RS-10-205
December 2, 2010

Subject: Clarification of Supplemental Information - License Amendment to Allow Receipt and Storage of Low-Level Radioactive Waste at LaSalle County Station, Units 1 and 2

Attachment: Clarification of Responses to Two Requests for Additional Information Concerning License Amendment to Allow Receipt and Storage of Low-Level Radioactive Waste at LaSalle County Station, Units 1 and 2, Facility Operating Licenses NPF-11 and NPF-18

Figure 1
LSCS Site Map

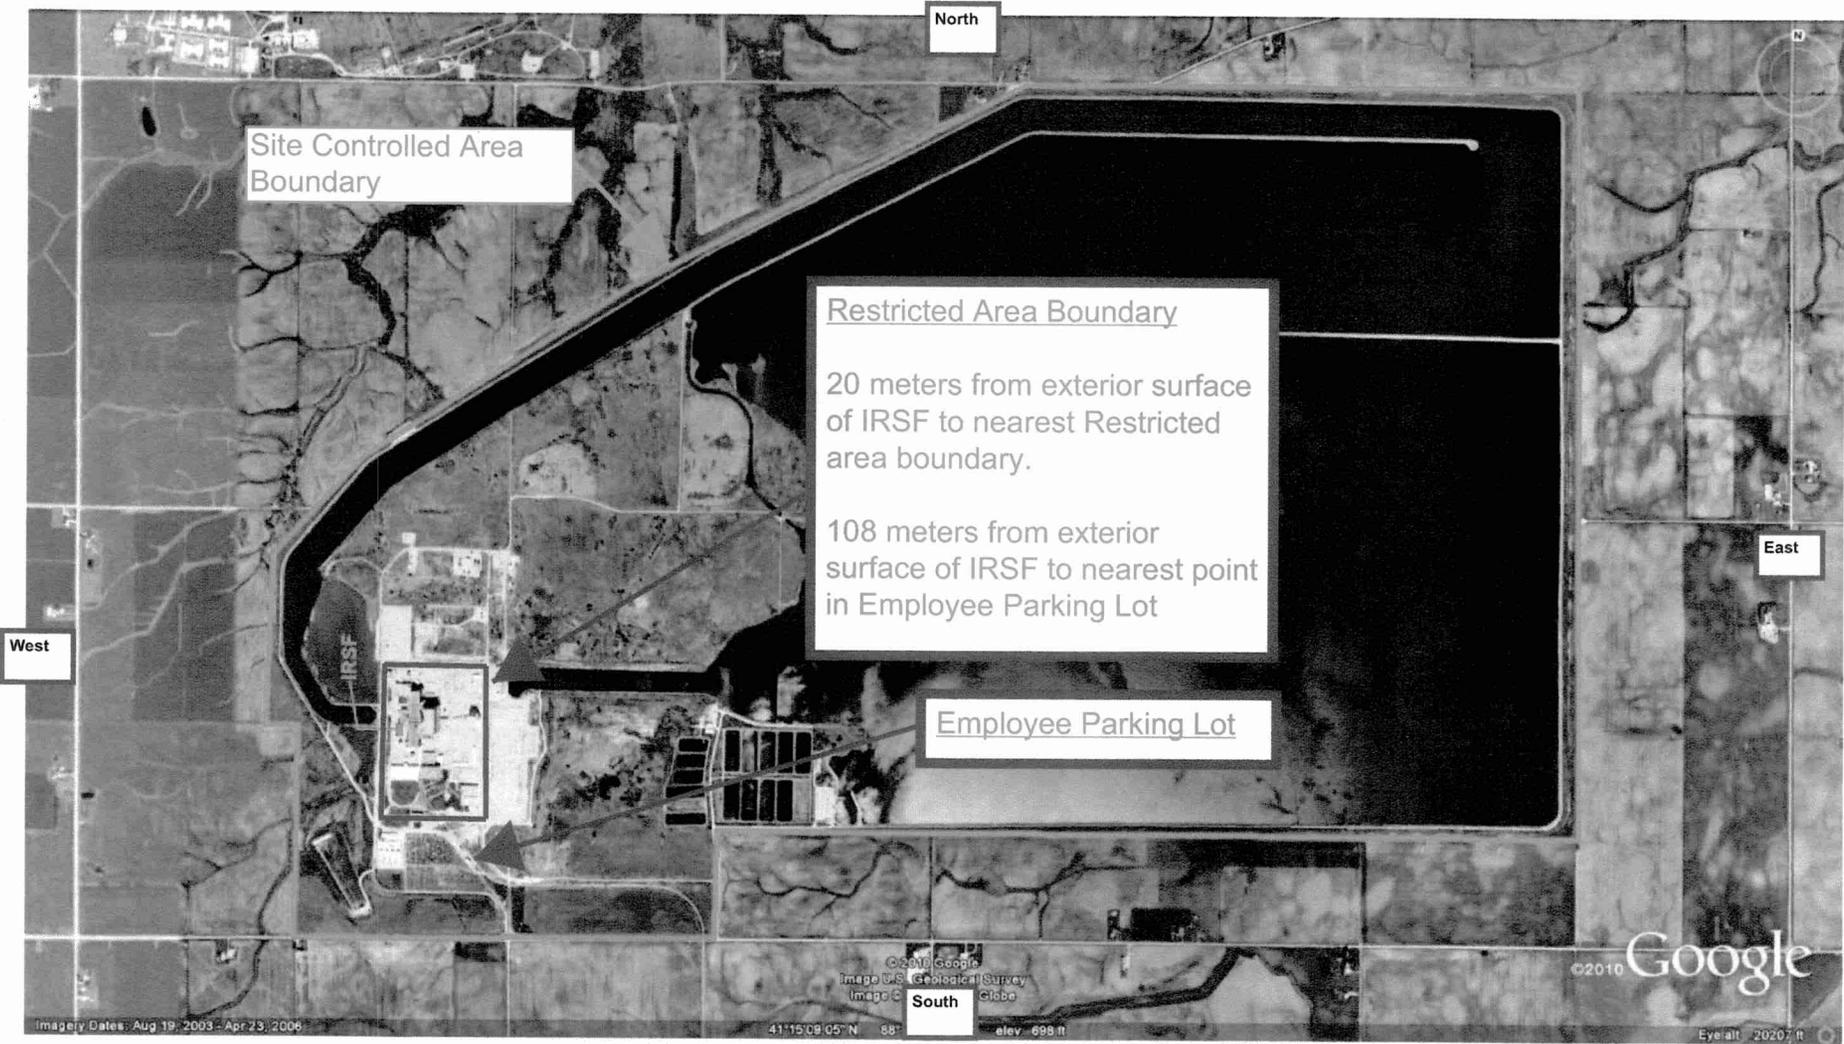
NRC RAI-07

"For onsite radiation protection purposes, describe the boundaries of the Title 10 of the Code of Federal Regulations Part 20 (10 CFR 20) controlled area (e.g., provide map and distances to the LLRW Storage Facility); describe whether members of the public are allowed in the controlled area, and describe how the dose limits of 10 CFR 20.1301(a) and (b) will be met."

The LSCS Interim Radwaste Storage Facility (IRSF) is located within the station protected area (PA), as well as within the site boundary (i.e., the Controlled area, as defined in 10 CFR Part 20.1003, "Definitions"). EGC limits unescorted access to the LSCS PA in accordance with the LSCS Security Plan as well as for the purpose of protecting individuals against undue risks from exposure to radiation and radioactive materials. Therefore, the LSCS PA also serves as the "Restricted area," as defined in 10 CFR Part 20.1003. Unescorted access to the Restricted area by members of the public is prohibited.

Figure 1, "LSCS Site Map," and Figure 2, "LSCS Controlled Area and Restricted Area" provides overhead depictions of the LSCS site. These figures identify the location of the IRSF relative to the Restricted area boundary, the Controlled area boundary, and an employee parking lot. As noted on Figures 1 and 2, the nearest Restricted area boundary is approximately 20 meters from the exterior surface of the IRSF. The nearest point in the employee parking lot is approximately 108 meters from the exterior surface of the IRSF.

The LSCS Controlled area is totally owned and controlled by EGC. As such, EGC controls access in accordance with the EGC Security Plan. While individual members of the public have the ability to access the employee parking lot (i.e., an unrestricted area within the Controlled area) from the plant access road, extended presence of these individuals within the employee parking lot will be identified by LSCS Security personnel within a short period of time and those individuals will be removed, in accordance with the requirements of the LSCS Security Plan. Similarly, the movement of an unauthorized individual by foot from the employee parking lot to the southern Restricted area boundary will be identified within a short period of time by Security personnel, and that individual will be removed, in accordance with the requirements of the LSCS Security Plan. Individual members of the public do not have the capability to access any other unrestricted area within the Controlled area.
